08V-461
(6 Pages)

**Regarding: 2007 Model Year XF50 and XC50 Connecting Rod
Factory Modification Campaign**

2007 XC50W (“Vino Classic”) and XF50W (“C³”) Scooters FACTORY MODIFICATION CAMPAIGN – Connecting Rod

IDENTIFICATION PROCEDURE

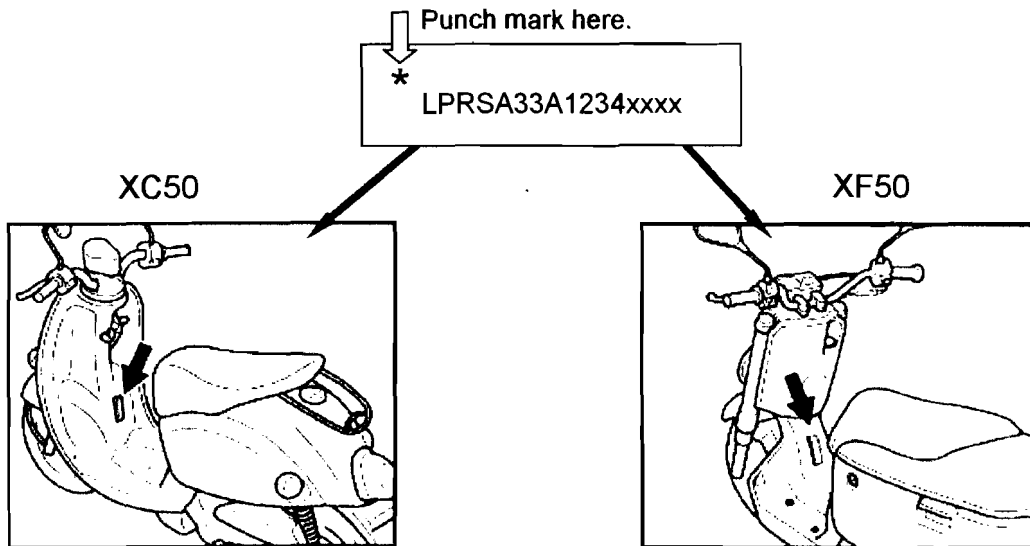
When the modification is complete, put a punch mark next to the Primary ID as shown. Check for this punch mark if you encounter an unfamiliar unit. You can also check unit status on YDS or by contacting your Regional Technical Advisor.

Casting lot number

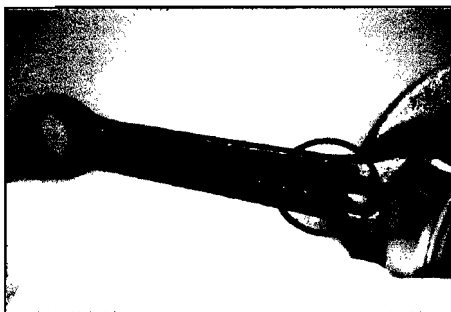
To identify a crankshaft assembly with an improperly treated connecting rod, look at the casting lot number:

Model	Incorrect Connecting Rods	Correct Connecting Rods
XC50W	12 and 13	Other numbers
XF50W	07, 08, 09, 10,11,12, and 13	Other numbers
